Overview: Production error in version 1.0 harnesses; The immobilizer wire (orange/black) is in pin position #4 instead of pin position #5. Although an effort to correct the issue was made, some quantity of harnesses did get shipped before the issue was spotted. We are advising to inspect the harness BLADE connector before attempting to install harness or program the module. This issue is not known to affect the version 2 harnesses, which require no modification.

Overview: Early versions of the FTI-STP1 harness require modification for **automatic transmission (AT)** applications, some of the product was able to be modified before release, but a small quantity was released without modification.

FTI-STP1: Installation and Configuration Notes

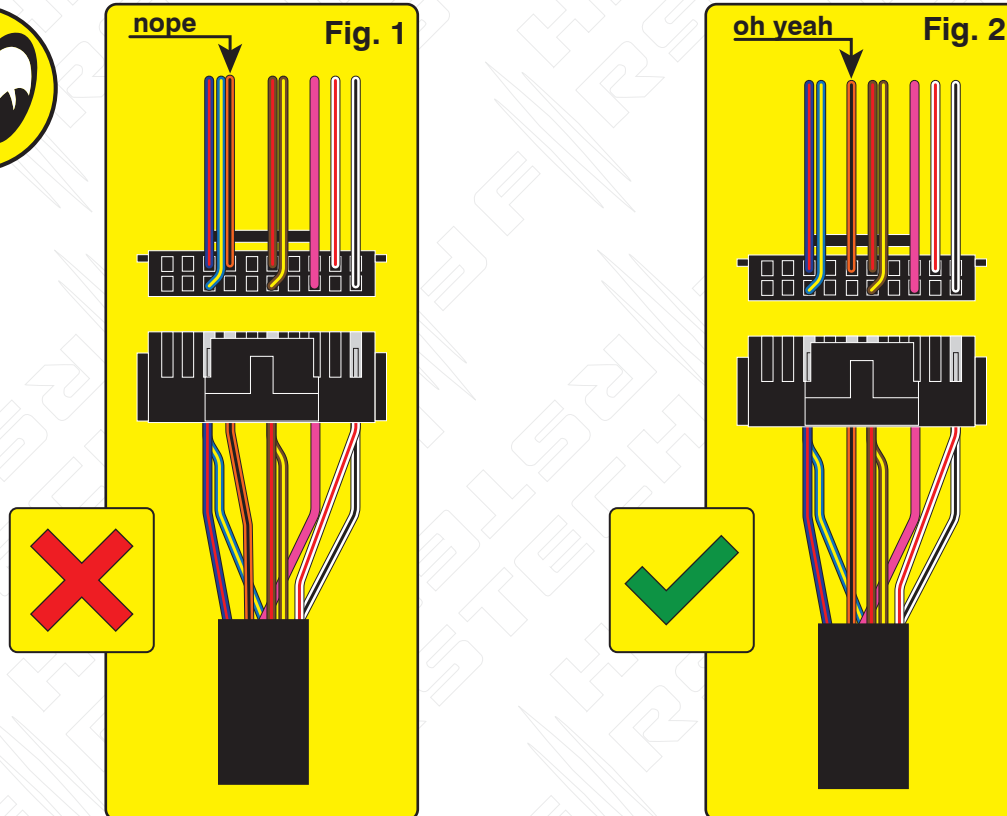
Issue: Module fails to program correctly to vehicle, does not allow the vehicle to be remote started.

Correction: Step 1.) Locate the orange/black wire and confirm whether it is positioned as illustrated in Fig. 1 or Fig. 2. If the wire is as illustrated in Fig.1, proceed with Step 2 through 5 and complete the repair procedure outlined, if the wire is as illustrated in Fig. 2, correction is not necessary, proceed with harness installation and module programming.

Step 2.) Using a pick, lightly depress the catch that secures the terminal in the housing then remove the wire and terminal from the housing.

Step 3.) Using a fine tip razor or utility knife, insert the blade beneath the terminal catch and raise it slightly, so that it can be reused to secure the terminal when reinserted into the BLADE connector housing.

Step 4.) Refer to Fig. 2 for correct position of the orange/black wire (next to brown/red) then reinsert the terminal, pressing lightly until the catch 'snaps' into place, securing the terminal in the connector housing.

MODIFICATION REQUIRED FOR A/T APPLICATIONS, ONLY WITH v 1.0 HARNESS

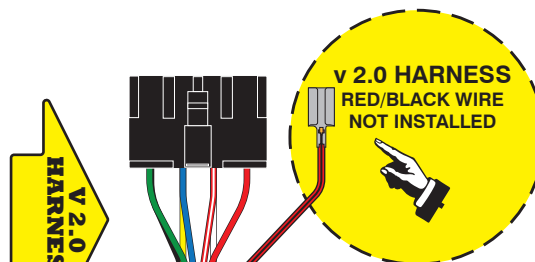
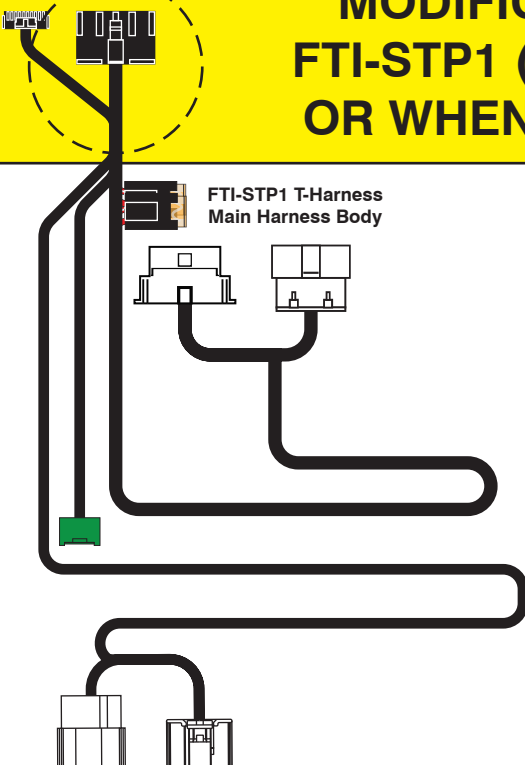
Issue: The FTI-STP1 T-harness has been designed to be compatible with A/T (automatic transmission) & M/T (manual transmission) applications, but due to an oversight in early production runs, the selection was defaulted to M/T mode.

Using a harness configured for an M/T application, in an A/T equipped vehicle, could result in vehicle module damage, it is advised that the harness be returned to A/T mode before installation in vehicles equipped with an automatic transmission.

Correction: Locate the **red/black (+ Clutch)** wire provided in the CN1 connector of the main harness assembly. Cut the **red/black** wire, either flush to the CN1 connector, or leaving enough wire exposed so that you can insulate and secure the ends of the wire that remain after cutting. Insulate each of the remaining ends of the **red/black** wire and secure to prevent any possibility of a short circuit. **If the red/black wire has already been disconnected, no further modification is required for A/T applications**
